Delmore Fast Track Application

Appendix 8: A19 (Stormwater and Geomorphology) to Response to Comments letter

Re: Response to Annexure 19 to Auckland Council Response – Stormwater and Geomorphology

Subject: Delmore Development Geomorphic Assessment. Response to Council RFI Memo (25.03.2026)

Figure 1 Valley-bottom Delineation

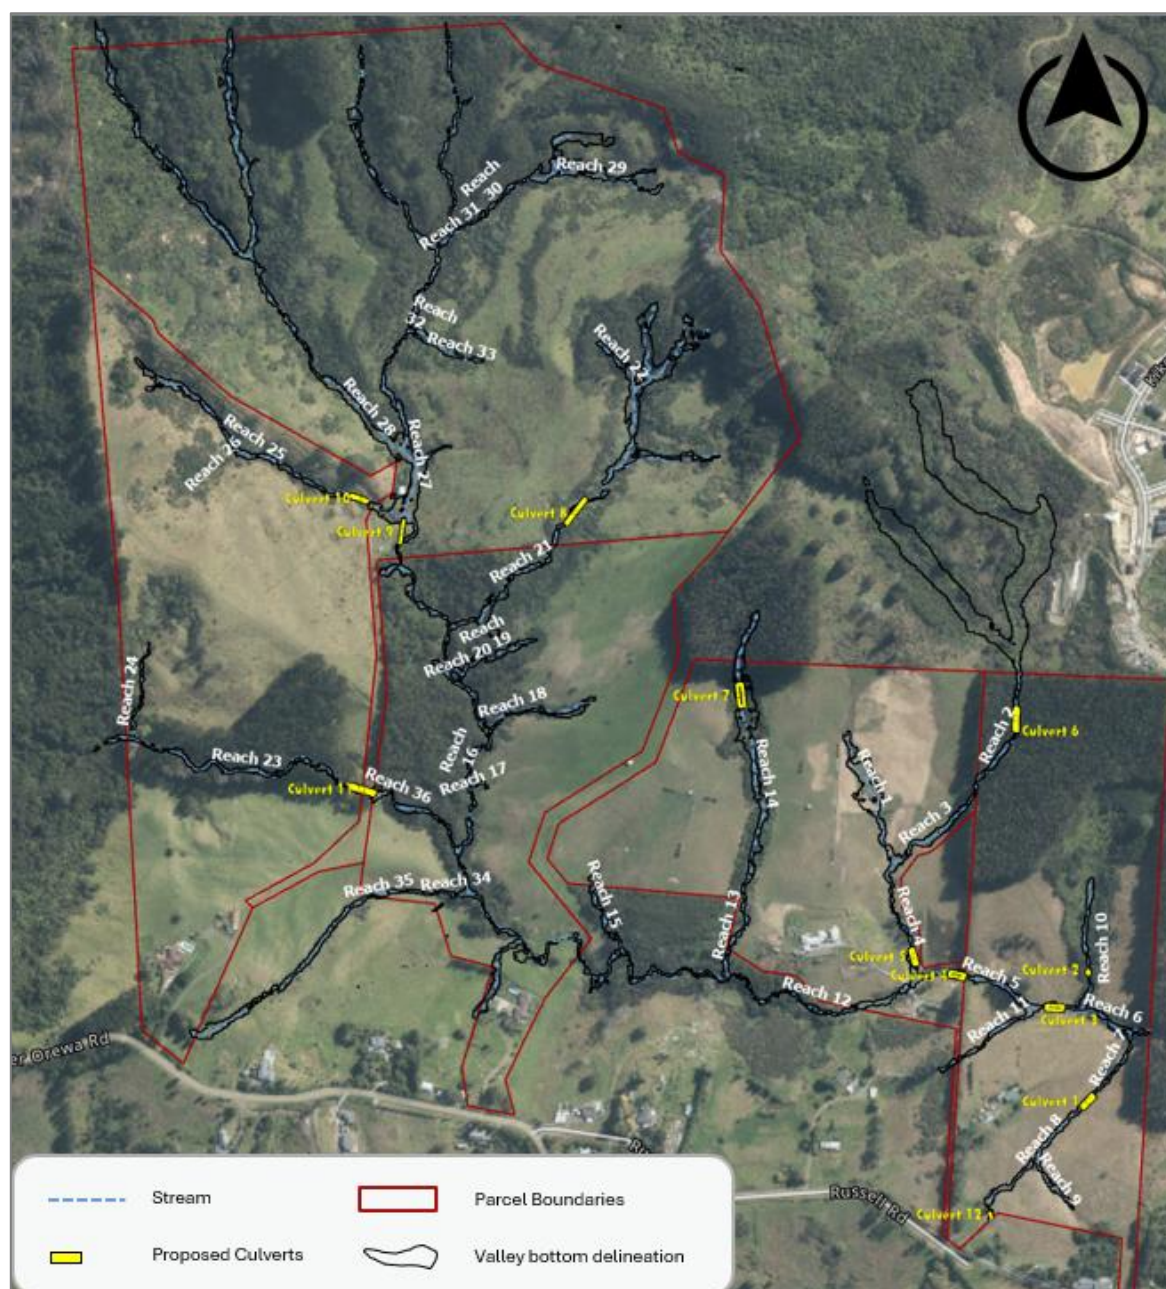
B1. Riparian setbacks of 10 m are proposed for most reaches. No analysis has been provided demonstrating how a 10 m horizontal setback accommodates future geomorphic adjustment over a 50-100 year planning horizon, including	- Refer to the memo prepared by Morphem in Attachment A. - Riley: As above, the stability analyses and assessment of required stability enhancement measures has considered 2m of downcutting and 3m widening as advised by Morphem. Refer

A relative elevation analysis was undertaken to define an indicative valley-bottom corridor across the site by comparing ground surface to an interpolated streambed surface (Figure 1). This allows terrain elevation to be expressed relative to the local channel and provides a consistent basis to identify the active or near-active valley floor.

For the primary stream network (including Reaches 6, 5, 12, and 36), the indicative corridor is typically on the order of approximately 3 to 5 m on either side of the stream centreline. This is interpreted to represent the active adjustment corridor, within which incision, toe erosion, and widening are expected to occur.

For lower-order streams, the corridor is generally narrower, although wider extents are observed in wetland-associated reaches (including Reaches 1, 14, 3, and 35), where low gradients and saturated conditions result in a broader zone of geomorphic activity.

Figure 2 Valley-bottom corridor and the proposed setback

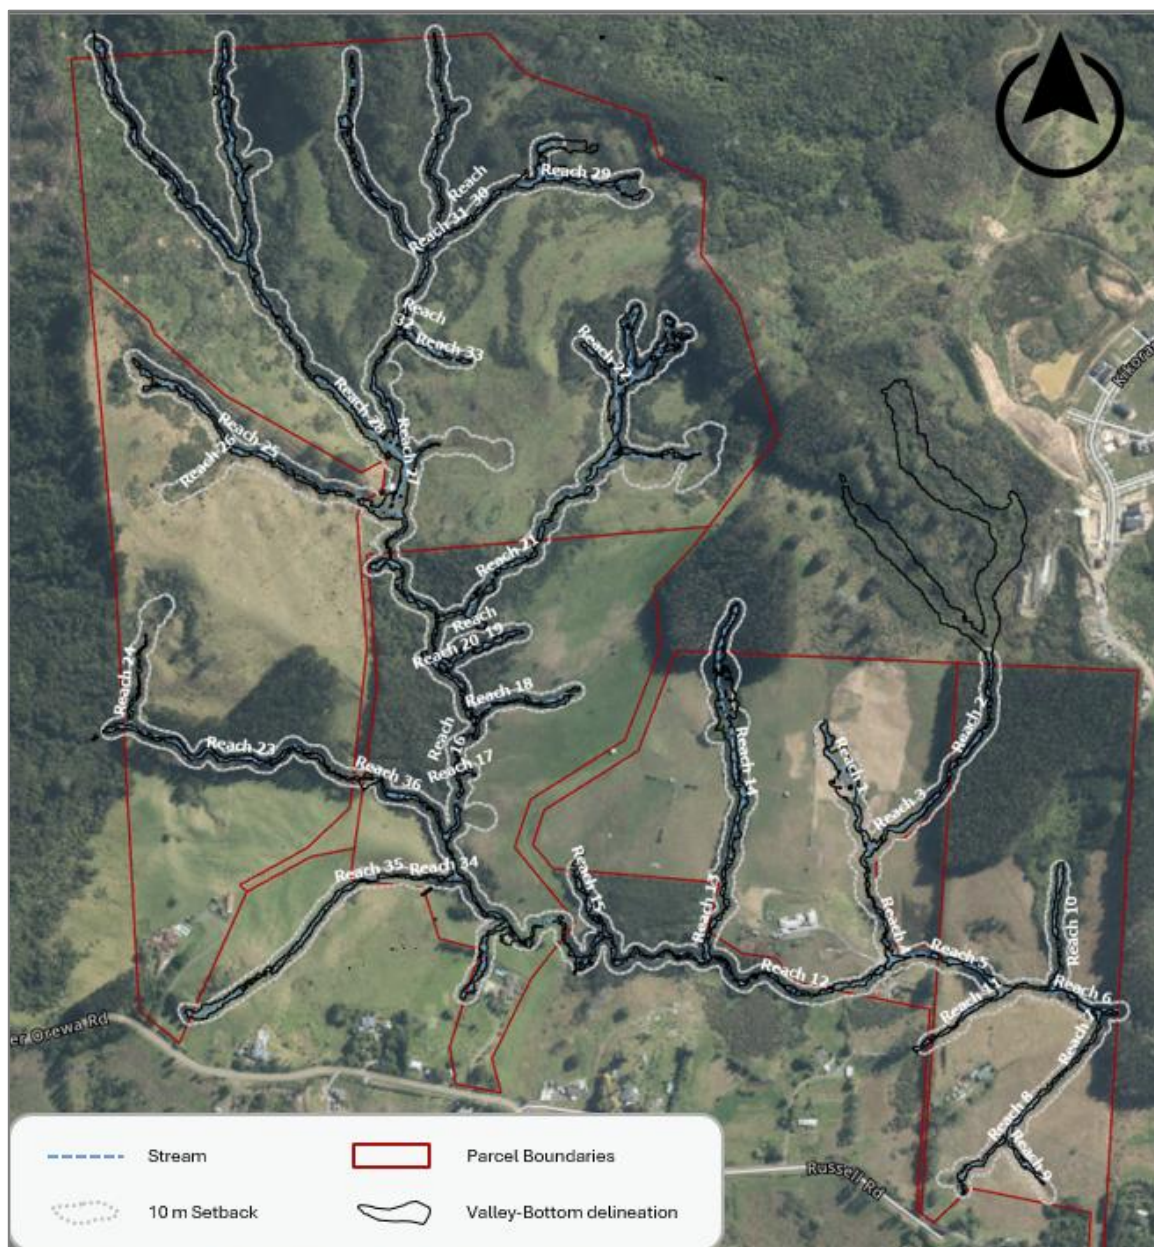
anticipated bed lowering of 1-2 m, progressive bank steepening, and associated slope destabilisation. Setbacks appear to be assumption-based rather than derived from geomorphic analysis. • For each actively adjusting and potentially actively adjusting reach, please provide a reach-specific justification for the proposed setback that accounts for the full anticipated adjustment trajectory, including vertical adjustment and its lateral consequences.	Section 5.1.3, page 17 of our GIR, Riley ref:240065-Q, also our memo on Geomorphic Impacts on Slope Stability, Riley ref: 240065-T.
B2. Where layout constraints prevent an increase in setback, the engineering response must be explicitly designed and costed for the full anticipated geomorphic adjustment, not current channel conditions. The application does not demonstrate that proposed retaining structures are designed to this standard. • Where proposed lots or structures cannot be set back to accommodate anticipated channel adjustment, please confirm that all stream-margin retaining and geotechnical structures are designed for the full anticipated bed lowering and bank steepening trajectory, including scour depth assumptions, and that this is documented in the geotechnical design.	• Refer to the memo prepared by Morphum in Attachment A. • Riley: As above, the stability analyses and assessment of required stability enhancement measures has considered 2m of downcutting and 3m widening, and setbacks as advised by Morphum. Refer Section 5.1.3, page 17 of our GIR, Riley ref:240065-Q, also our memo on Geomorphic Impacts on Slope Stability, Riley ref: 240065-T

The indicative valley-bottom corridor has been used to provide spatial context for this assessment. The adopted 10 m setback generally extends beyond the identified zone of active geomorphic adjustment, providing a margin to accommodate anticipated widening associated with incision and bank instability.

When considered together with the expected magnitude of incision (1–2 m) and associated lateral widening, the identified valley-bottom corridor provides a reasonable basis to infer that future channel adjustment is likely to remain within a lateral extent encompassed by the proposed setback across most reaches.

A 10 m setback is therefore generally considered appropriate from a geomorphic perspective. This reflects the confined nature of the system, the expected magnitude of widening relative to valley-bottom width, and the absence of significant planform migration.

Figure 2 shows the relationship between the indicative valley-bottom corridor and proposed setback.

Figure 3 Velocity change (m/s) for the 1% AEP event with climate change (3.8°C), calculated as post-development minus pre-development conditions.

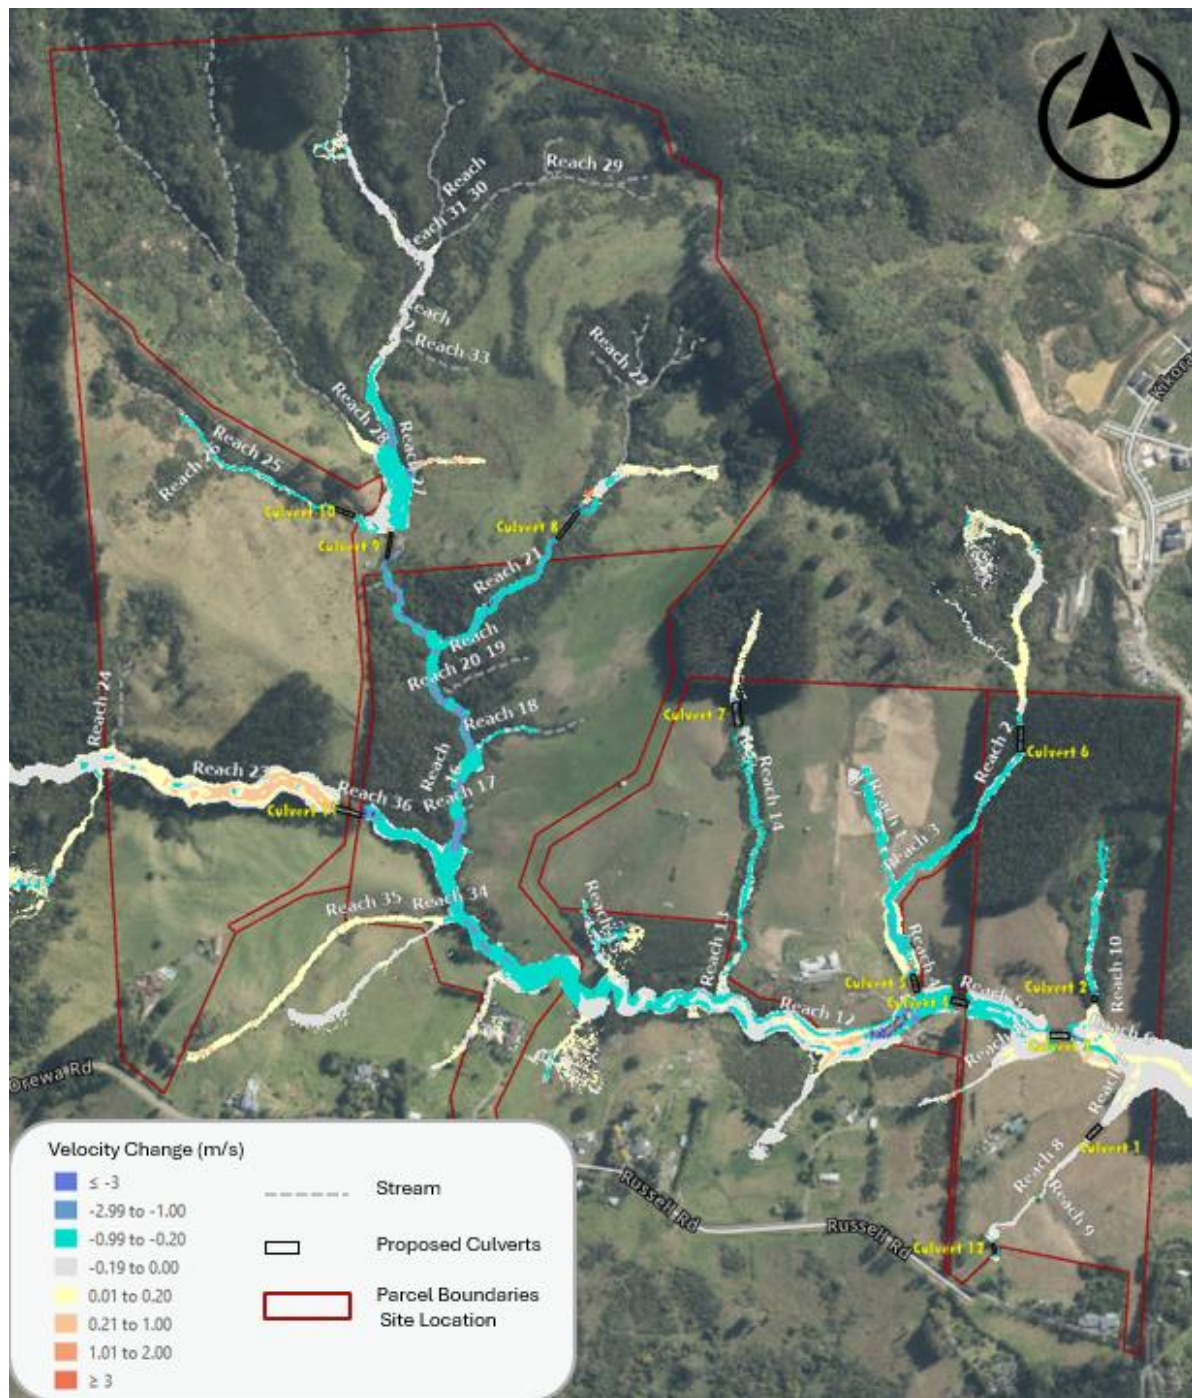
C1. The geomorphic assessment acknowledges that development will alter the stream hydrograph, increasing flow peaks and efficiency of delivery. No analysis is provided of how post-development hydrology, including increased imperviousness, altered flow duration and frequency, and more efficient stormwater conveyance, will interact with the active geomorphic processes documented across the network. • Please provide an assessment of how post-development hydrological changes will affect the rate and extent of channel incision, knickpoint migration, and bank widening across the network.	Refer to the memo prepared by Morphum in Attachment A, including the hydraulic inputs at Appendix 1 of that document.
C2. The hydraulic model (McKenzie & Co, drawings 3725-0-4506 and 3725-0-4507) shows post-development 50% AEP velocities at monitored locations. These figures were not considered or referenced in the Morphum Geomorphic Assessment or Geomorphic Response Memo,	Refer to the memo prepared by Morphum in Attachment A, including the hydraulic inputs at Appendix 1 of that document.

C3. At the 10% AEP, post-development velocities show reductions of approximately 10 to 26 percent at several locations. This is noted. However, even with these reductions, velocities at multiple locations remain above the critical erosion thresholds for the silt/clay channel materials documented across the network. The application does not demonstrate that the network is designed to accommodate the geomorphic forces generated by flows at and below the 10% AEP. • Please demonstrate that the stormwater network design accounts for the geomorphic forces generated by the full range of flows from the 10% AEP downwards, whether through increased channel resistance, adequate setbacks for adjustment, or both.	Refer to the memo prepared by Morphem in Attachment A, including the hydraulic inputs at Appendix 1 of that document.
C4. The hydraulic model provides peak velocity snapshots at the 50% AEP and 10% AEP. No long-term gauged flow record exists for this catchment, and no flow frequency or duration analysis has been provided. Channel morphological adjustment is governed by the frequency and cumulative duration of flows exceeding the erosion threshold,	Refer to the memo prepared by Morphem in Attachment A, including the hydraulic inputs at Appendix 1 of that document.

Figure 3 shows the velocity change (m/s) for the 1% AEP event with climate change (3.8°C), derived from hydraulic modelling provided by McKenzie, calculated as post-development minus pre-development conditions.

Hydraulic outputs have been reviewed to identify wetlands potentially affected by concentrated flows and increased velocities. Velocity change mapping (Figure 3) indicates that wetland-associated reaches (including Reaches 1, 3, 8, 19, and 25–28) generally experience either a reduction or only minor increases in velocity under post-development conditions. Where increases are observed, these are small in magnitude and are not considered sufficient to drive a transition from diffuse wetland flow to defined channelised conditions.
